Littleton King Street Common Phase 1 Retail Development - Peer Review

December 15, 2025

Review by Utile Architecture and Planning

Engage and activate King St

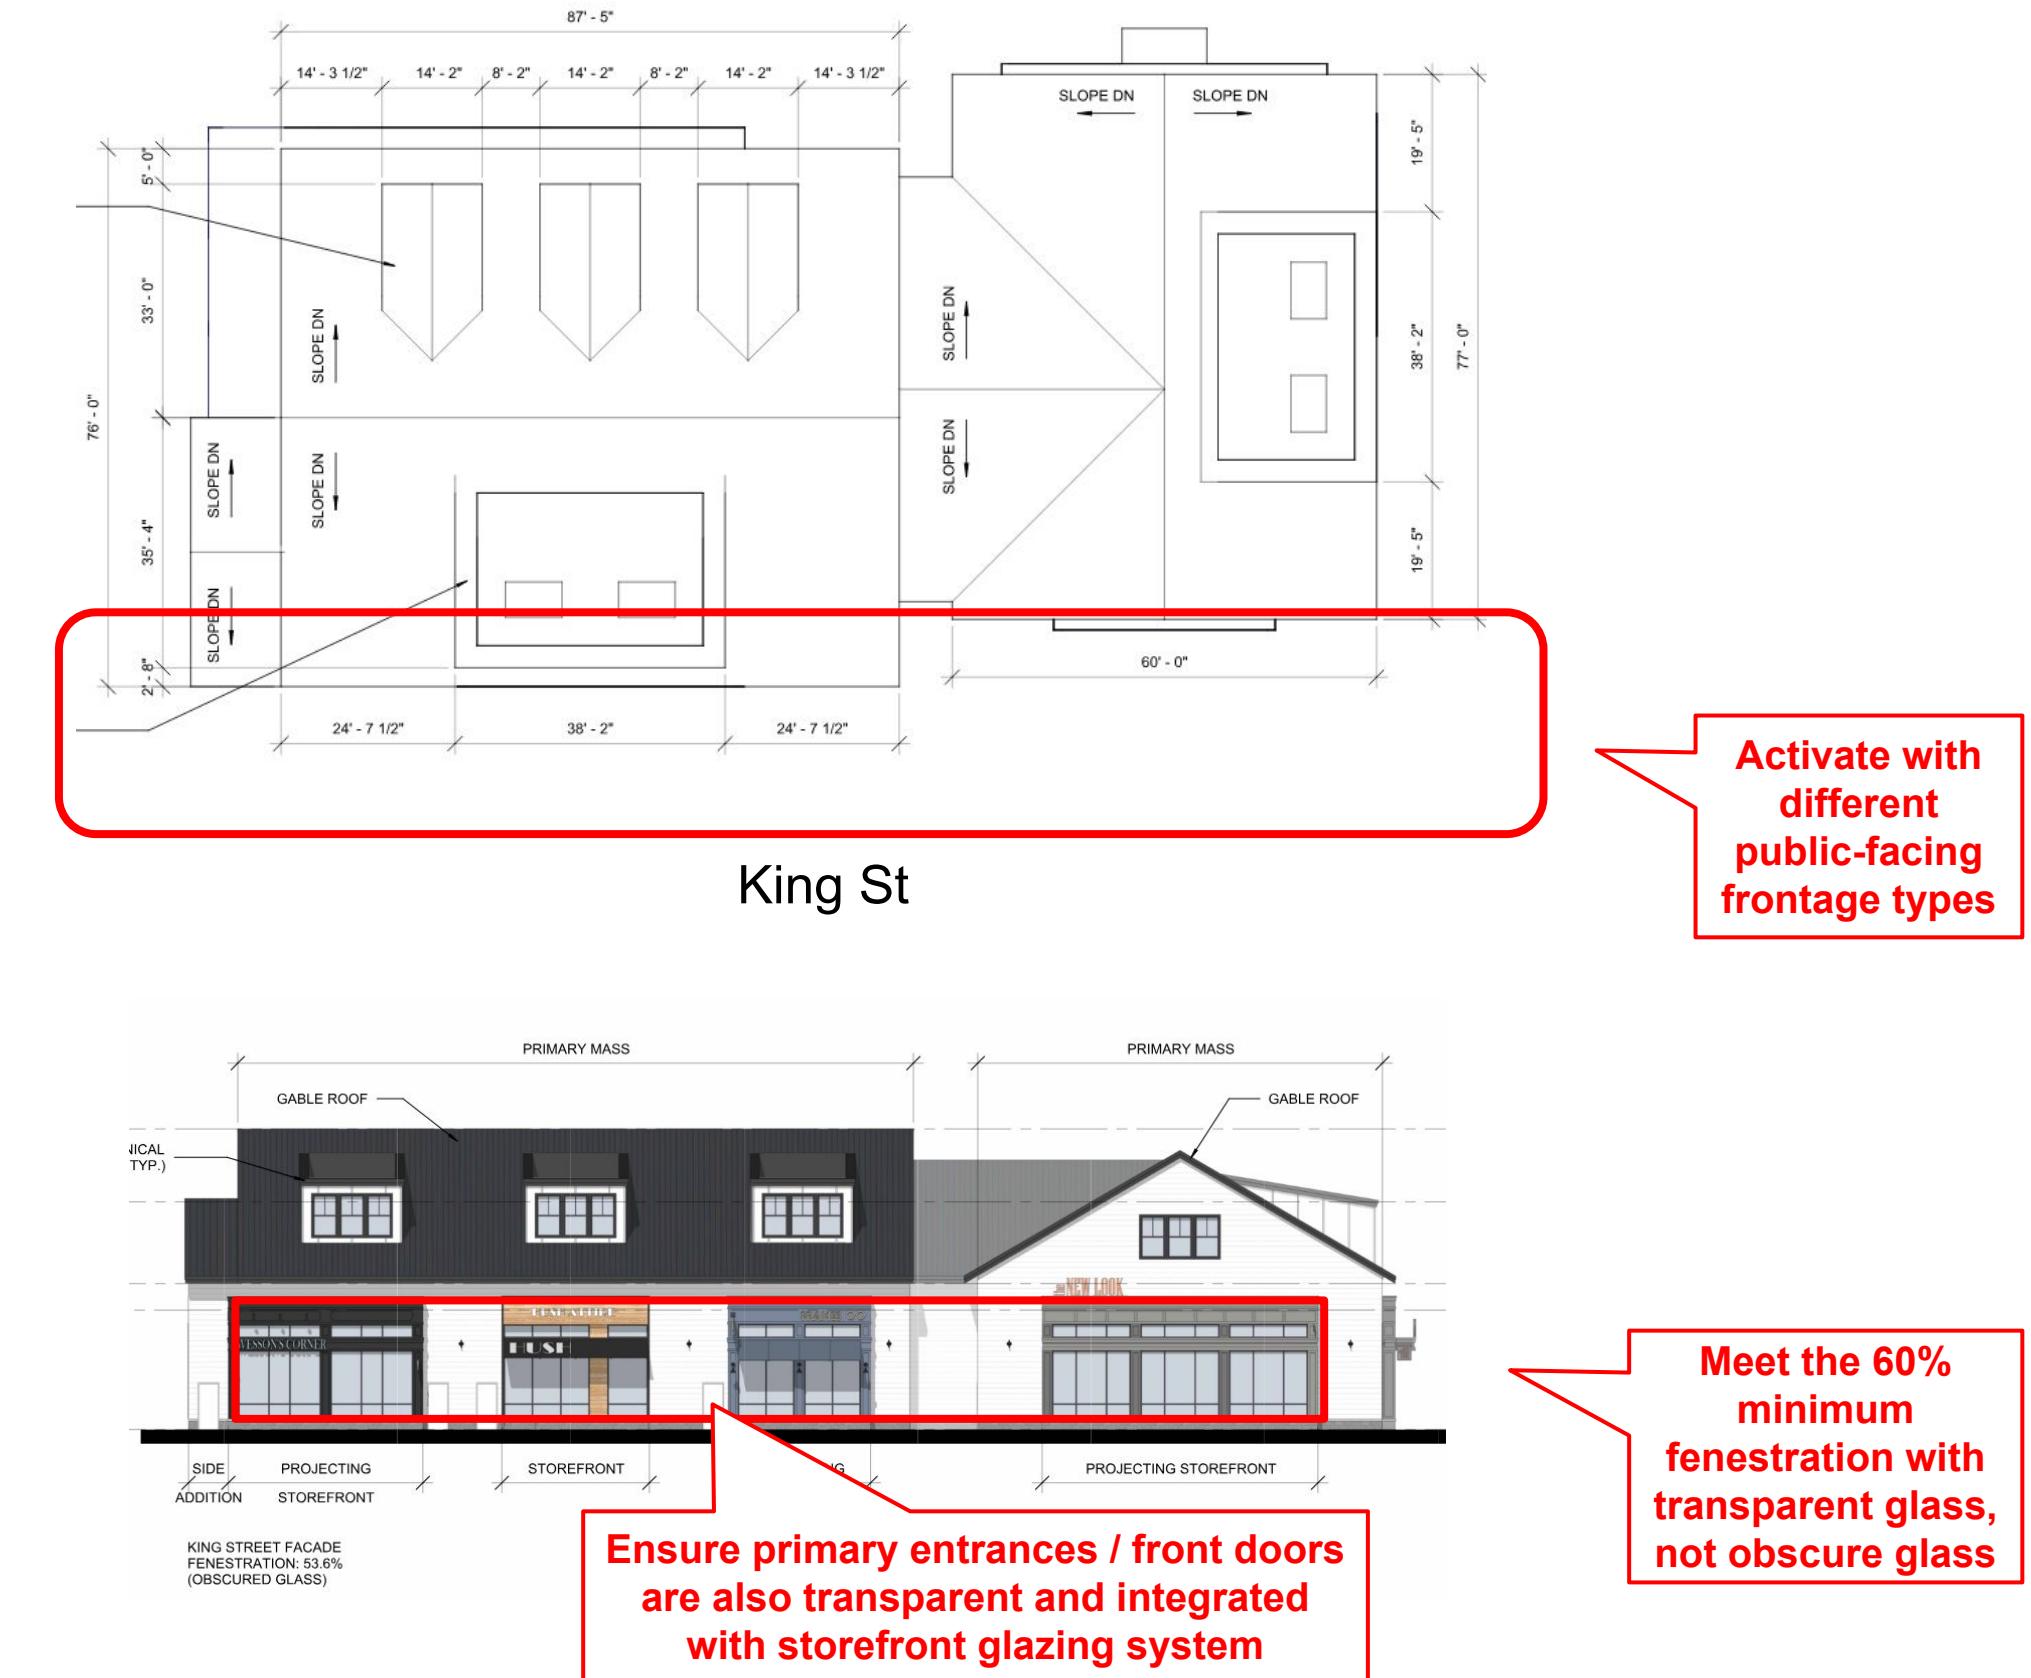
As mentioned earlier, the 3 buildings along King St (1200, 1400, and 1500) have effectively turned their backs onto the public way. To address this:

First, ensure the frontage area is a consistent with one of the *frontage types* that activates the sidewalk (e.g., entry plaza, dining patio, etc.). ([§173-221.N. Frontage Types](#))

Second, ensure that the *fenestration* along King St (aka window transparency percent) is at least 60% and made up of transparent glass, not obscure glass. ([§173-221.G. Fenestration](#))

Lastly, ensure that there are ample *front doors* / *primary entrances* along King St to invite pedestrians and signal a welcoming and active street environment.

Building-Specific Scale Comments: Building 1400

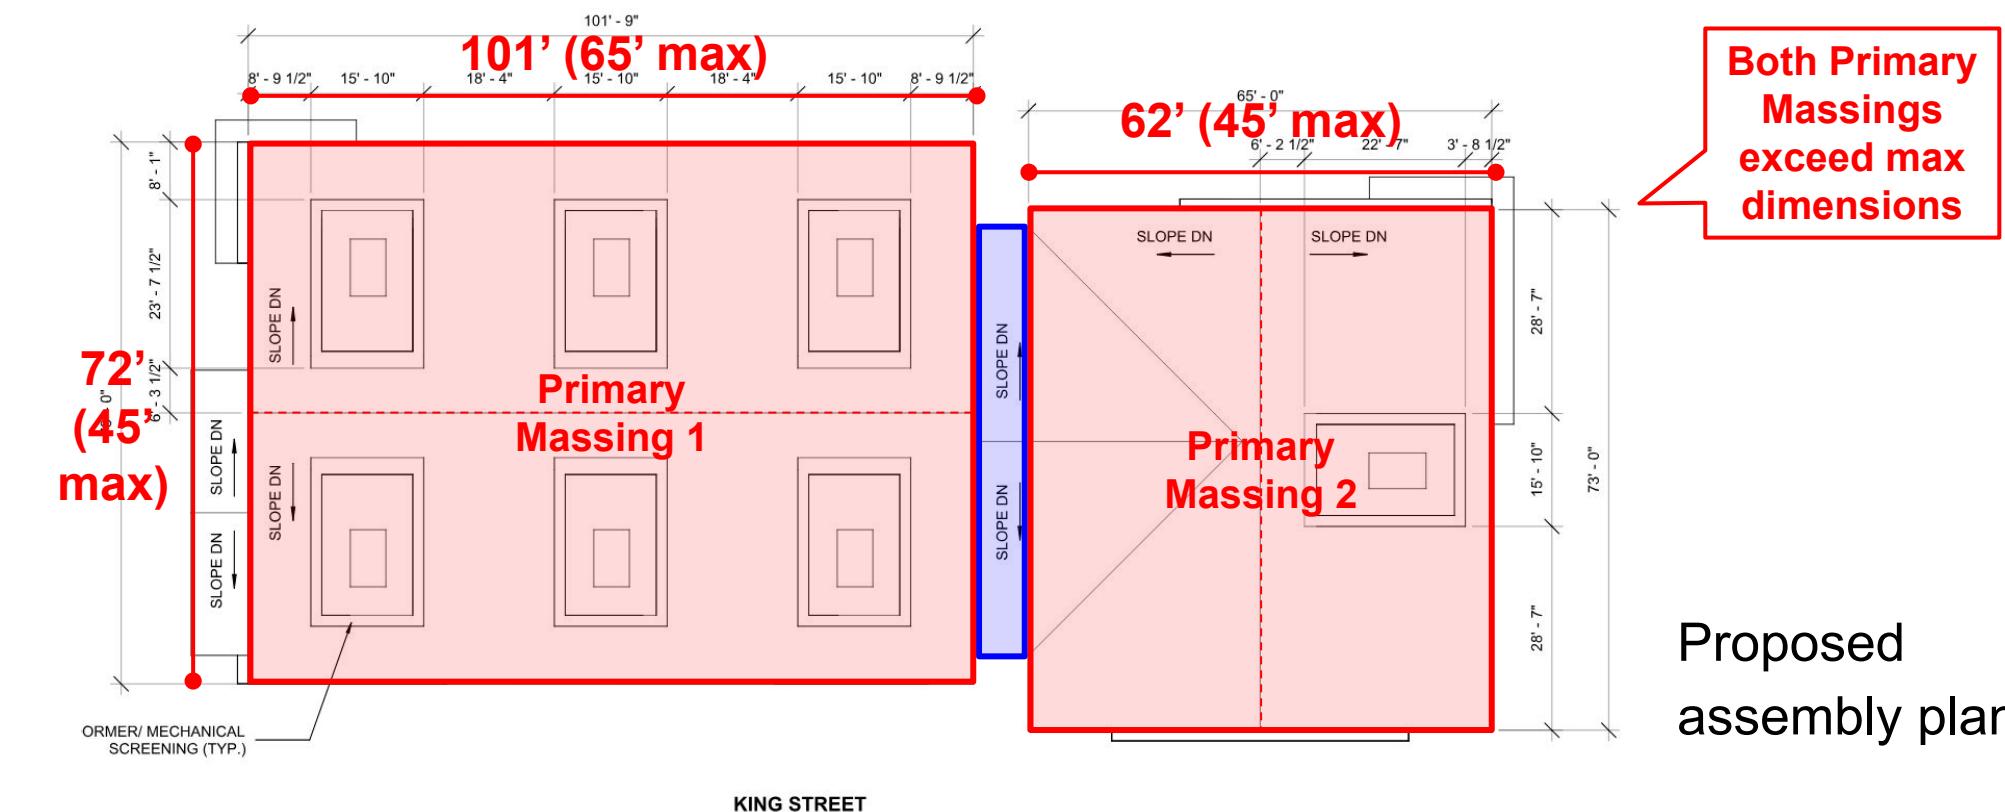
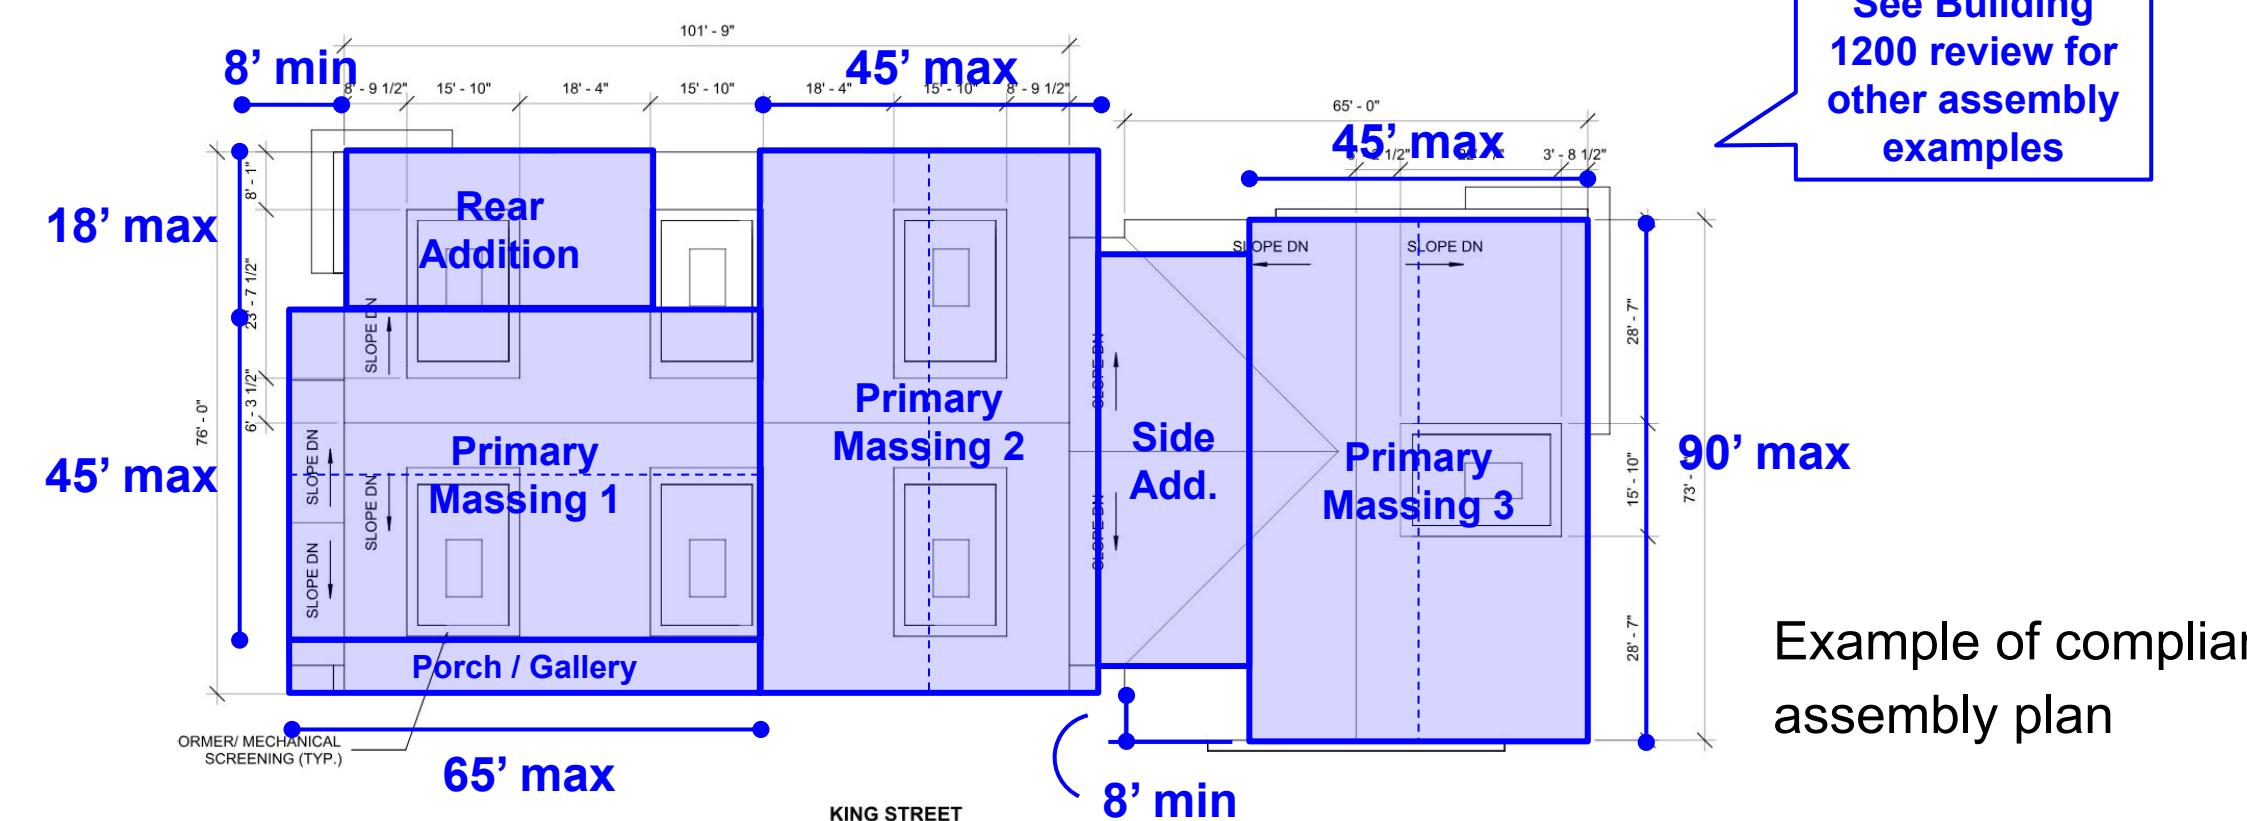
Similar to Building 1200, Building 1400's two primary massings both exceed the maximum allowable dimensions. The east primary massing is 101' wide by 72' deep, equalling an area ~ 2.5 times the allowable maximum for a single primary massing (65' wide by 45' deep, when the long side is oriented parallel to the ROW), resulting in an oversized building. (§173-221.K.)

As mentioned earlier, reducing the perceived building scale does not necessarily mean a significant reduction in the total building area / footprint – there are multiple options to create an assembly out of primary massing(s) and building component(s) that retain most/all of the area (see one example at right). (§173-221.M. Example Massing Combinations)

Building-Specific Scale Comments: Building 1400

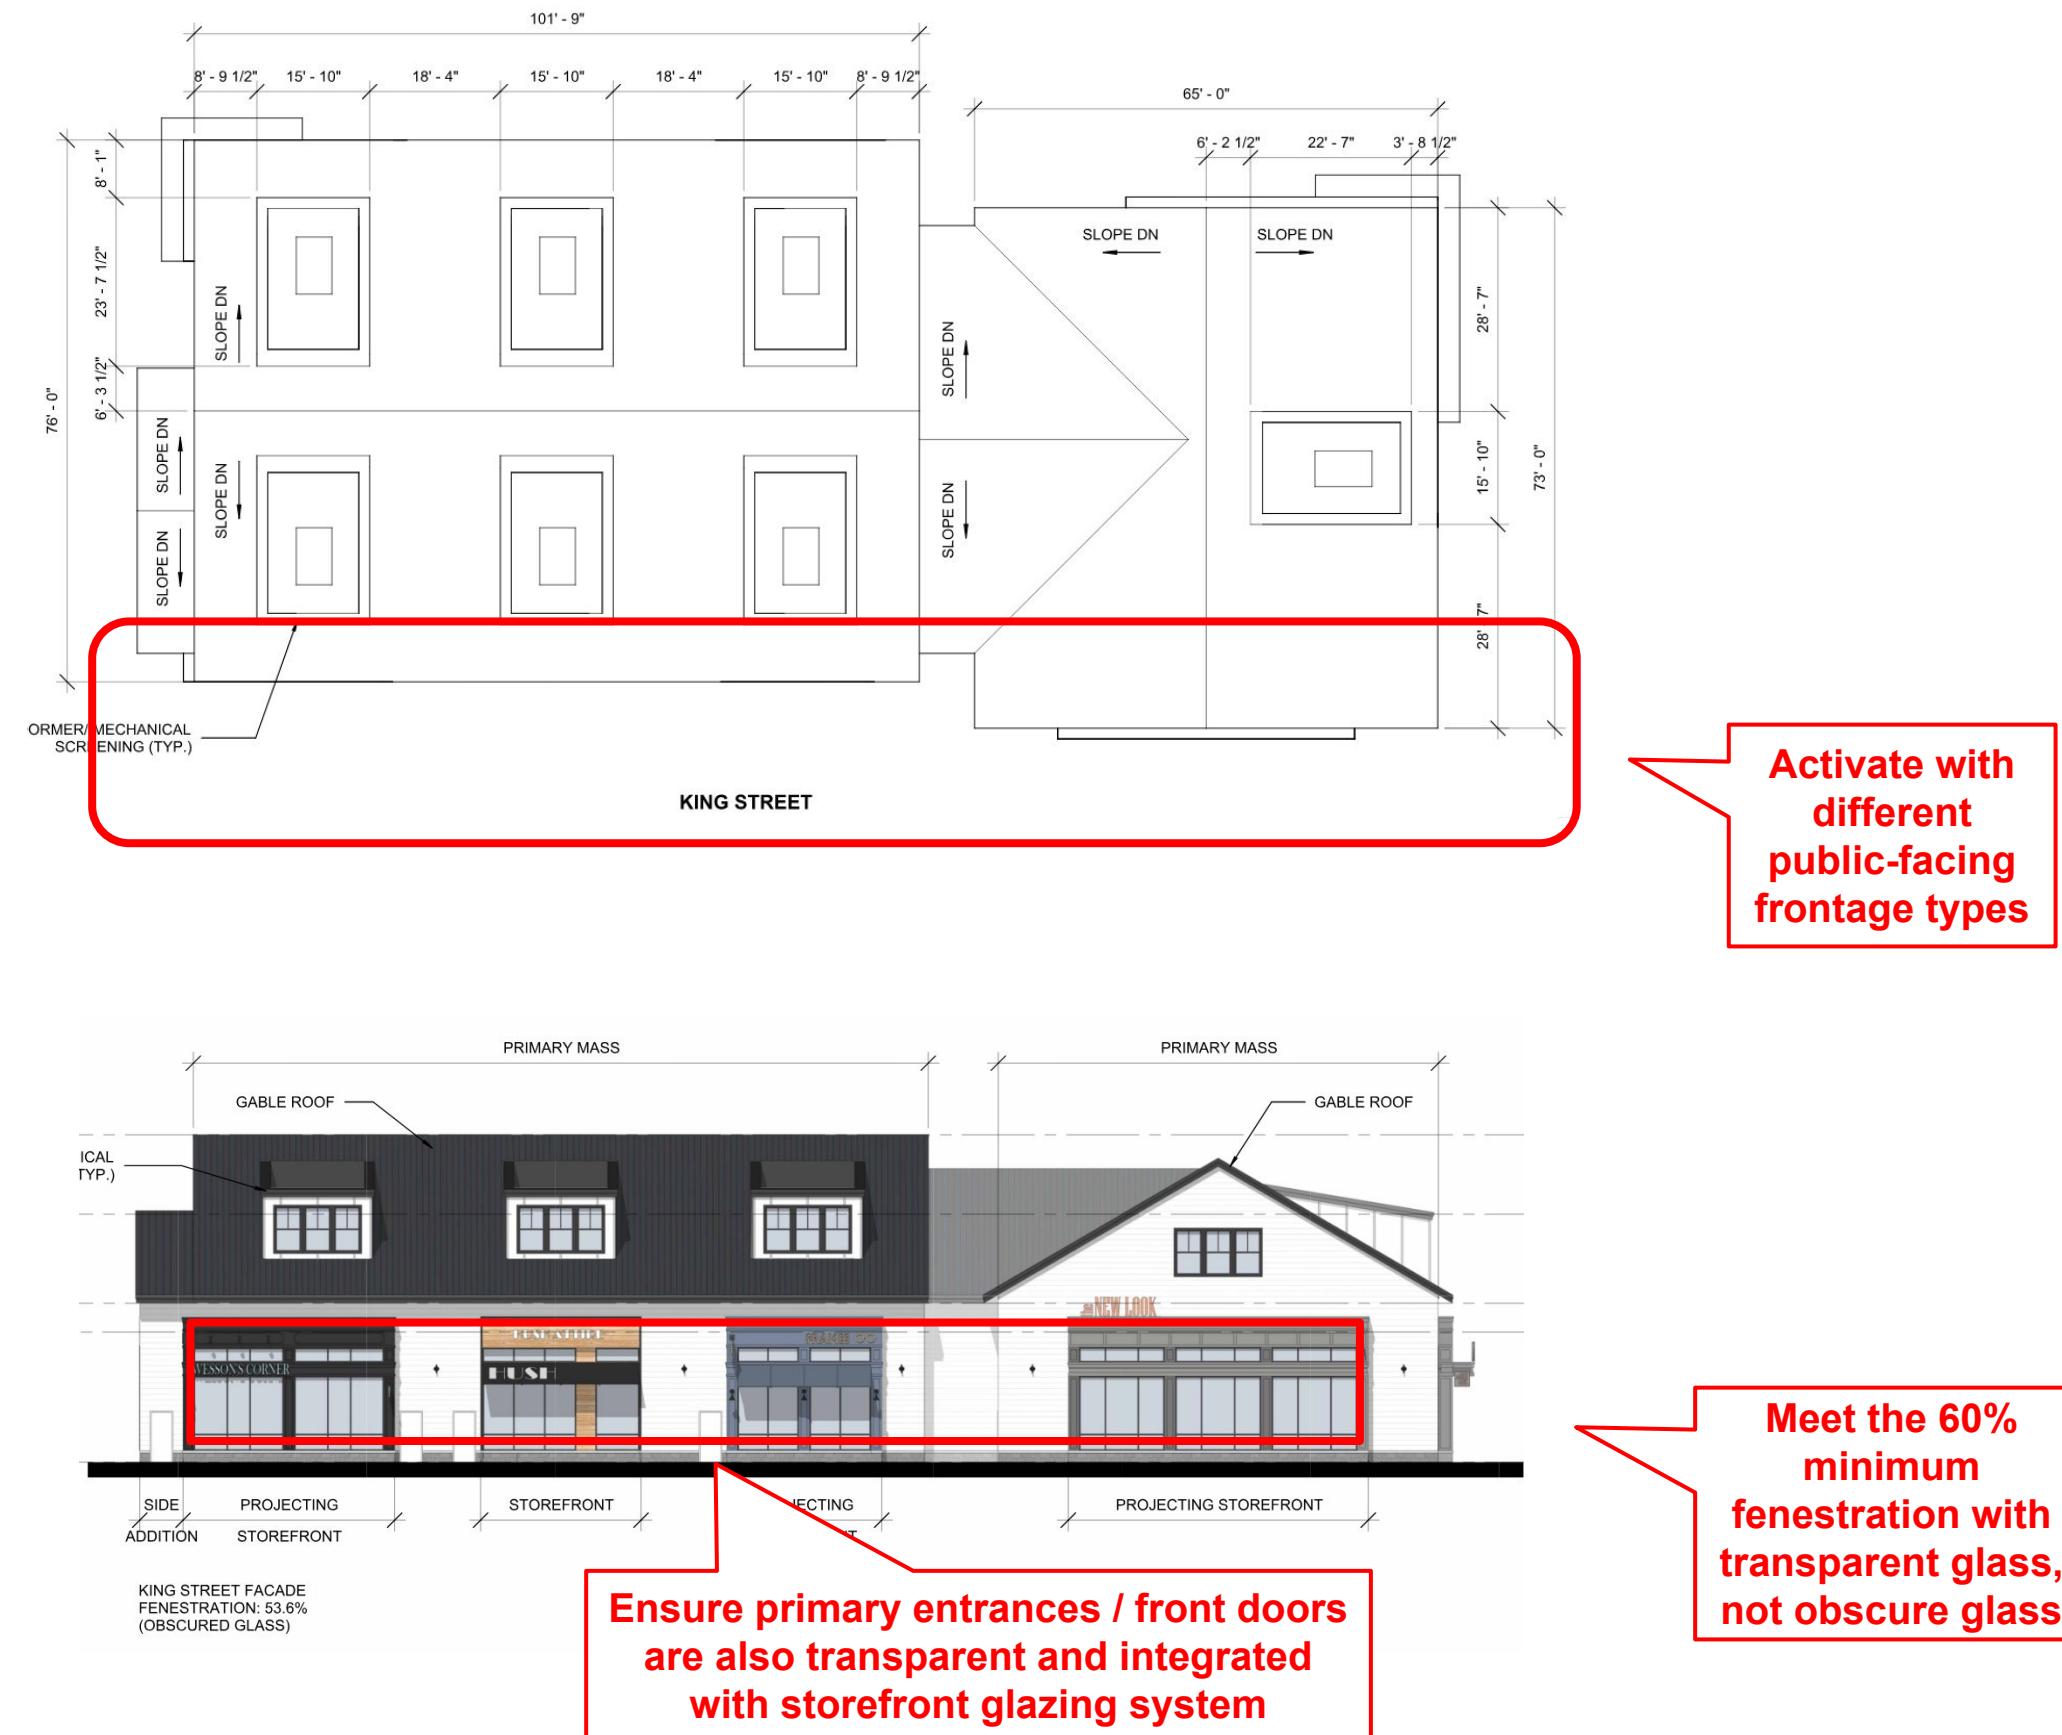
As mentioned earlier, the 3 buildings along King St (1200, 1400, and 1500) have effectively turned their backs onto the public way. To address this:

First, ensure the frontage area is a consistent with one of the *frontage types* that activates the sidewalk (e.g., entry plaza, dining patio, etc.). ([§173-221.N. Frontage Types](#))

Second, ensure that the *fenestration* along King St (aka window transparency percent) is at least 60% and made up of transparent glass, not obscure glass. ([§173-221.G. Fenestration](#))

Lastly, ensure that there are ample *front doors* / *primary entrances* along King St to invite pedestrians and signal a welcoming and active street environment. ([§173-221.J.b. Principal Entrance](#))
